CONSTRUCTION SUMMARY

Carrville Investments Ltd. / Richvale

Lot/Unit: 55 Phase/Building: 1 Model/Floor Plan: The Evergreen (20-4) Elev B

LOWER FLOOR ELEV 'A'

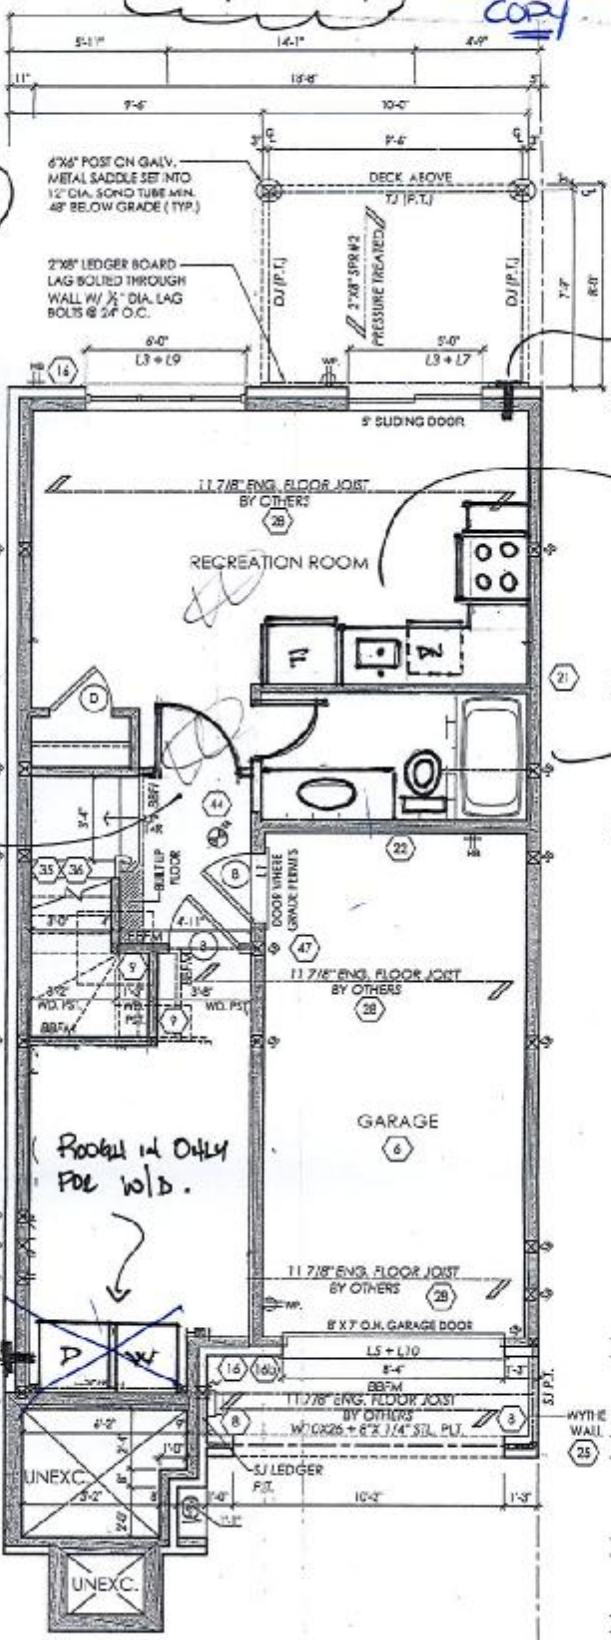
Inv.4031	1 - RECONFIGURE LOWER LEVEL BATH AS PER SKETCH ATTACHED.	
Line 51789	Note:	
9Feb17 / 10Feb17		
Inv.4031	1 - SUPPLY AND INSTALL ROUGH-INS FOR FUTURE KITCHEN, AS PER PLAN, TO INCLUDE ELECTRICAL FOR STOVE, DISHWASHER, FRIDGE, FAN AND COUNTER PLUGS.	
Line 51790	Note:	
9Feb17 / 10Feb17		
Inv.4031	1 - SUPPLY AND INSTALL ADDITIONAL 6" KITCHEN EXHAUST FAN VENT FOR FUTURE BASEMENT KITCHEN. LOCATION AS PER SKETCH ATTACHED.	
Line 51791	Note:	
9Feb17 / 10Feb17		
Inv.4031	1 - SUPPLY AND INSTALL WALL AND DOOR IN BASEMENT. LOCATION AS PER SKETCH ATTACHED.	
Line 51792	Note:	
9Feb17 / 10Feb17		
Inv.4031	1 - SUPPLY AND INSTALL 4" DRYER VENT TO MECHANICAL ROOM. LOCATION AS PER SKETCH ATTACHED.	
Line 51793	Note:	
9Feb17 / 10Feb17		
Inv.4031	1 - SUPPLY AND INSTALL ROUGH-IN ONLY FOR FUTURE WASHER AND DRYER IN MECHANICAL ROOM. LOCATION AS PER SKETCH ATTACHED.	
Line 51794	Note:	
9Feb17 / 10Feb17

ADDITIONAL 6" STOVE VENT

ROUGH-INS ONLY FOR FUTURE STOVE, FRIDGE SINK & D/W.

REBUILT WASHROOM LAYOUT

ADDITIONAL WALL & DOOR

ADDITIONAL 4" DRYER VENT
